STAFF REPORT

SUBJECT: H-2022-0015

Bountiful Commons - MDA, PFP

Modification to the existing Development Agreement (Linder Mixed Use - Inst. #2018-052340) to update the conceptual development plan & building elevations; and combined preliminary and final plat consisting of three (3) building lots on 2.20 acres of land in the C-C (Community Business) zoning district.

<u>Updated</u> (dated: 7/7/22):

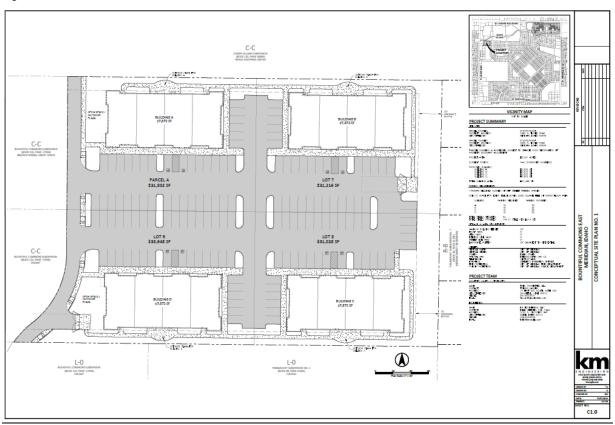
A north/south backage road exists along the west boundary of this site that provides an access from the collector street (W. Cayuse Creek Dr.) to the north to Linder Rd. at the south boundary of Bountiful Commons Subdivision. Staff is concerned the ten (10) parking spaces depicted on the site plan along the west boundary of the site will create a safety hazard by vehicles backing out into traffic; therefore, Staff recommends these spaces are removed from the plan.

An existing provision of the DA (#5.1b) requires a minimum of 5% of the development area to be developed with supportive and proportional public and/or quasi-public spaces and places. Based on 2.93 acres, a minimum area of 0.15-acre (or 6,382 square feet) would be required. In mixed use designated areas where multiple commercial and/or office buildings are proposed, the Comprehensive Plan also desires buildings to be arranged to create some form of common, usable area, such as a plaza or green space. To create more of a shared common usable area as desired, Staff recommends instead of individual outdoor plaza areas for each building, the parking areas in between Buildings A & B and C & D are removed and a plaza/green space is provided in these areas with seating, landscaping and shade structures.

- <u>4.</u> Commission change(s) to Staff recommendation:
 - a. None
- <u>5.</u> Outstanding issue(s) for City Council:
 - a. The applicant submitted a revised site/landscape plan after the Commission hearing that depicts the removal of 10 parking spaces along the west boundary of the site as recommended by Staff and the Commission. Other changes as recommended by Staff were not included in accord with the Commission's discussion (i.e. removal of individual outdoor plaza areas for each building and the parking areas in between Buildings A & B and C & D in favor of provision of plaza/green spaces in these areas with seating, landscaping and shade structures).

Staff recommends the Applicant revise the conceptual development plan depicted in Section VII.B to incorporate the changes noted in Section V.A and submit a copy of the revised plan to the Planning Division at least 10 days prior to the City Council hearing. A revised plan was submitted after the Commission hearing that incorporated some but not all of Staff's recommended changes (see Sections VI.B.5 and VII.B for more info).

PLAT OF Bountiful Commons Subdivision No. 2

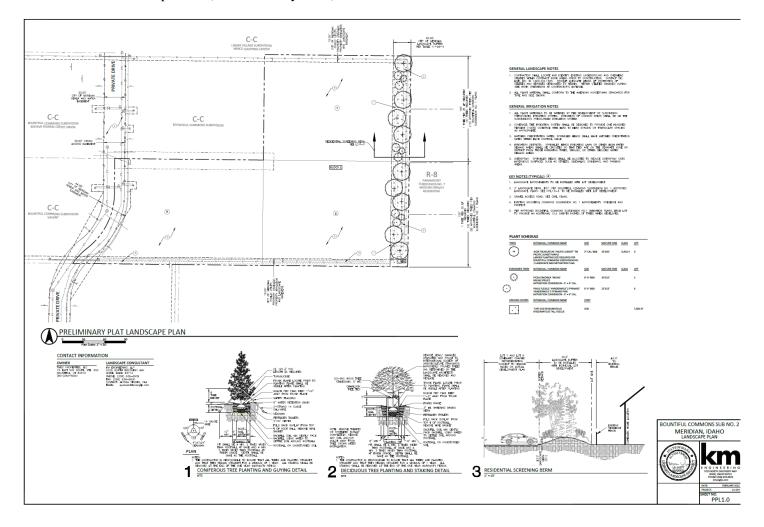
- 2. The final plat shall include the following revisions:
 - a. Include the recorded instrument of the City of Meridian sewer and water easement graphically depicted on Sheet 1.
